# **Final Environmental Impact Statement for the COB Energy Facility**

**DOE/EIS-0343**

**Bonneville Power Administration**

June 2004

**Figure 2-6**  
 City of Malin Visual Resource Map  
 COB Energy Facility  
 Bonanza, OR

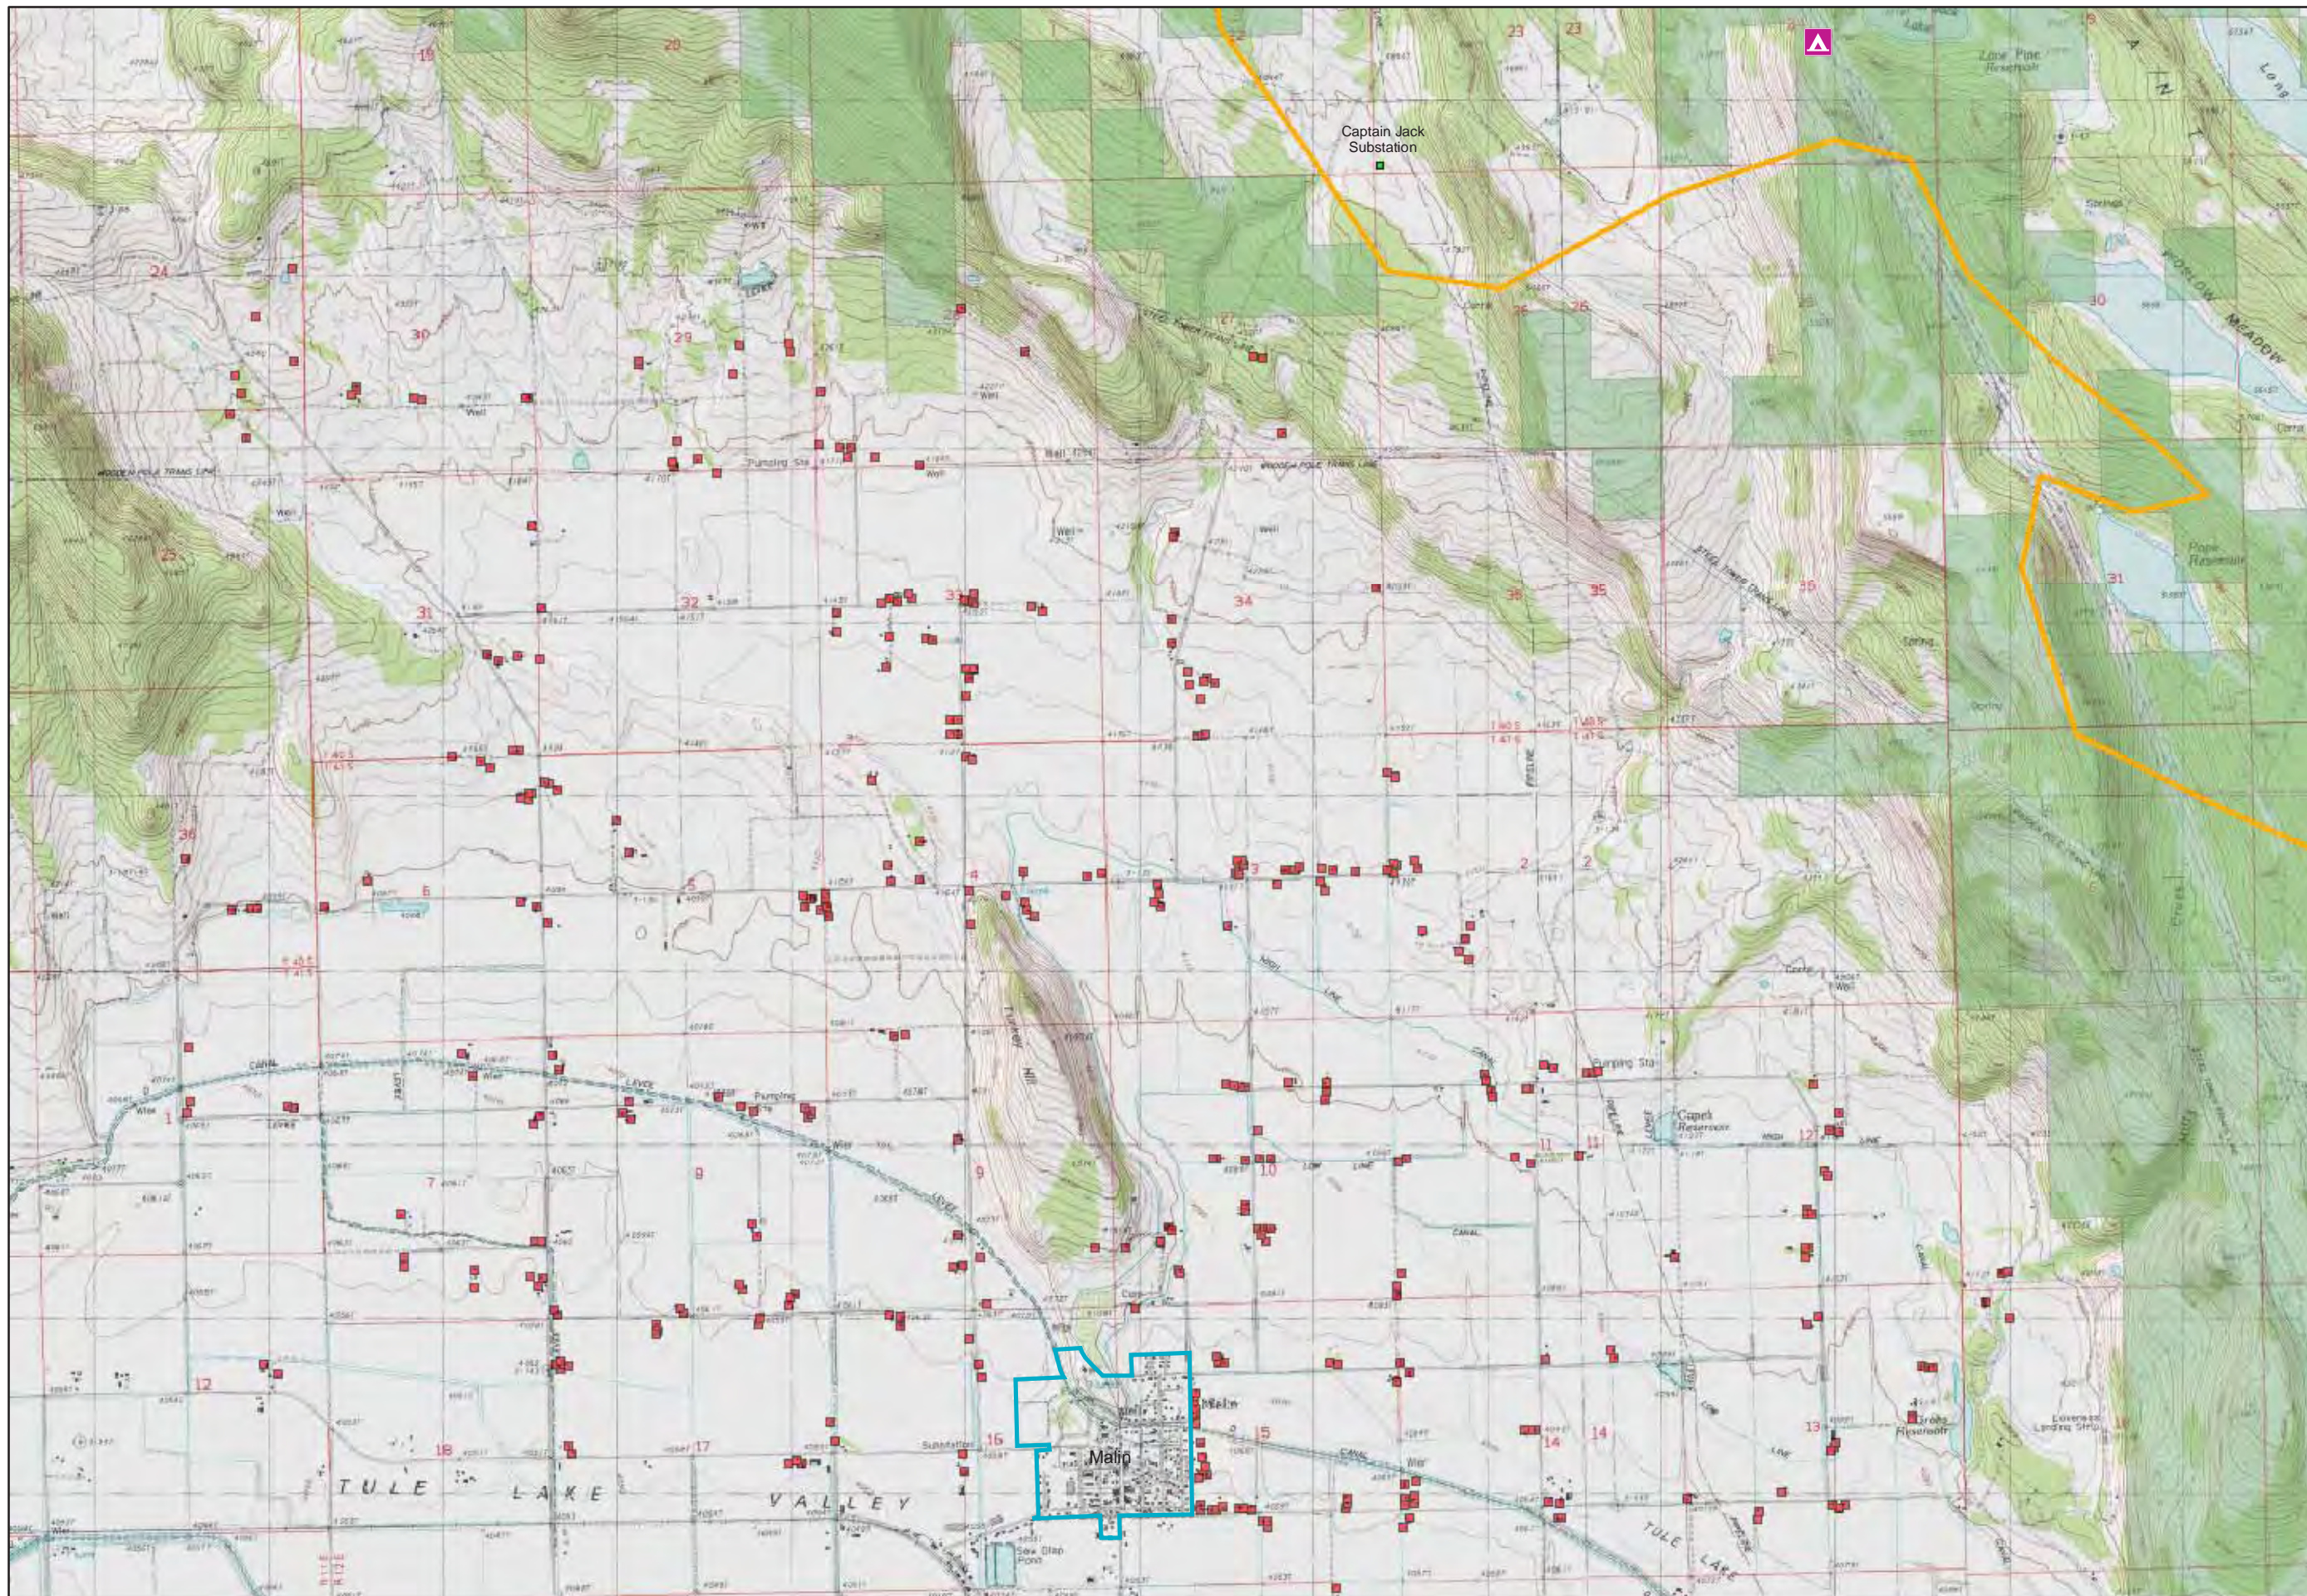
- M5 Pages 3.8-1 and 3.8-2, Sections 3.8.1 and 3.8.2: The “Bumpheads” are shown on Figures 3.8-1, 3.8-2, and are listed in Table 3.8-1, but are not described here in the text. Also, Alkali Lake and Yainax Butte are shown on Figures 3.8-1 and 3.8-2, but are not discussed here in the text. The Department recommends you provide a brief description of these areas, and reference the KFRA Resource Management Plan Environmental Impact Statement (RMP-EIS), where a full description is provided.

VS Page 3.8-9, Figure 3.8-1; Page 3.8-11, Figure 3.8-2: It is not clear what the three black circles on these figures represent. Based on the discussion on page 3.8-3, under Impact 3.8.1, it appears they have something to do with “three sets of visual analyses” that were performed, but that still doesn’t tell the reviewer what the symbols mean.

Table 3.8-1	3.8-7	28U5	<b>Revisions to the Table. See Part 2 New or Revised Tables.</b>
Figure 3.8-1 and 3.8-2	3.8-8 3.8-9	28W5	<b>Revisions to the Figure. See Part 3 New or Revised Figures.</b>
<b>3.9 Cultural Resources</b>	3.9-1	28Y5	<b>Revisions to third paragraph.</b> Cultural resource investigations have been conducted in cooperation with the Klamath Tribes. A Cultural Resources Management Plan (CRMP) would be prepared in consultation with the tribes that describes monitoring activities during construction of the Facility and the actions to be taken if an unanticipated cultural resource site <u>were</u> discovered during construction or operation <del>would be managed and protected.</del> of the project.
